SUBJECT: NuScale Power, LLC Response to NRC Request for Additional Information No. 289 (eRAI No. 9215) on the NuScale Design Certification Application

NuScale Response to NRC Request for Additional Information eRAI No. 9215

NRC Question No.: 06.02.05-10

Figure 1: Bay Height

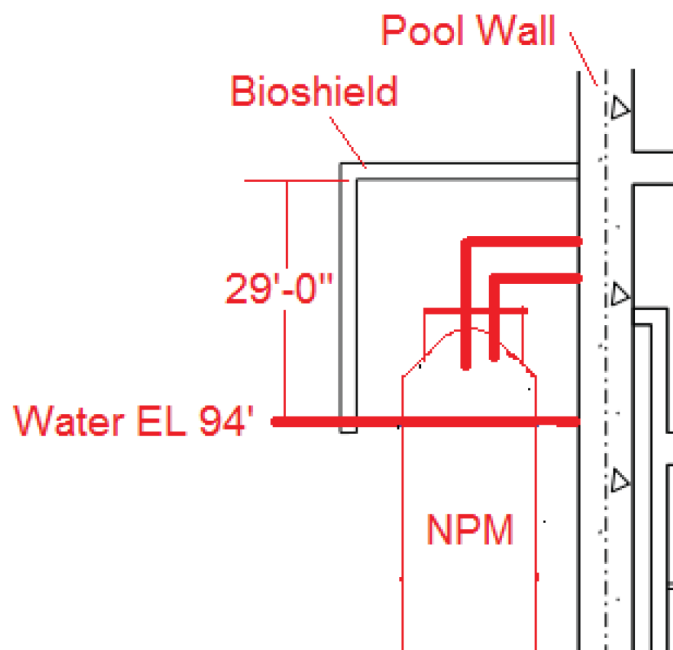
- 1) Describe the region / compartment above the containment vessel and below the bioshield, including clarifying the above statements. Provide the volumes, elevations, and shapes of each compartment. Provide dimensions and compositions of the solid structures (walls, etc.) that bound or define the compartment. Additionally and/or alternatively, provide drawings of or describe the gas-occupied compartment immediate above the reactor bay pool.

The NRC has correctly understood the configuration of the operating bay surrounding the NPM. Using FSAR Tier 2, Figures 1.2-19 and 3.8.2-3 as reference, Figures 1 and 2 of this response show that the volume created by the bioshield, operating bay and pool walls, and the water surface is as follows: the distance between the bay walls is approximately 19'-7" from inside face to inside face (Figure 2 below), the distance from the pool bay wall to the vertical portion of the bioshield is approximately 20'-1" from inside face to inside face (Figure 2 below), the distance from the pool water to the horizontal portion of the bioshield is 29'-0" from the water surface (EL 94') to inside face (Figure 1 below), and the containment vessel occupies space approximately 5'-2" above the water surface and is approximately 14'-9" in diameter. Above the module, space is occupied by various pipe, electrical/I&C SSC, and steel. This is the only compartment enveloped by the operating bay walls, pool wall, bioshield, and pool water surface, and the space/volume can be described as a cube with the upper module and supporting SSC occupying some of that space. The dimensions and compositions of the solid structures are the same for a single bioshield and stacked bioshield configuration.
